Modification to run CPUxxCMI on 3MHz bus.

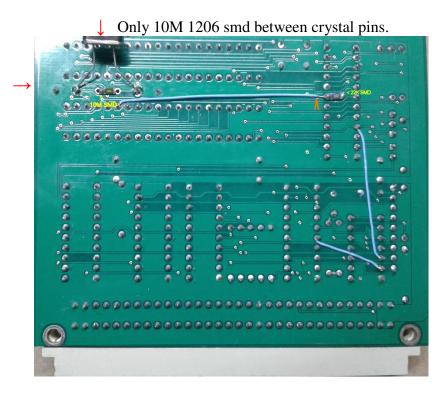
Replace xtal into 12MHz. Replace C1 and C2 by 15 pF. Place 10M 1206 smd between crystal pins. Use the HD63C09, M68B09 or MC68B02.

But for the HD63C09 add the Q clock for a better timing. See "Modification to run CPUxxCMI on 4MHz bus".
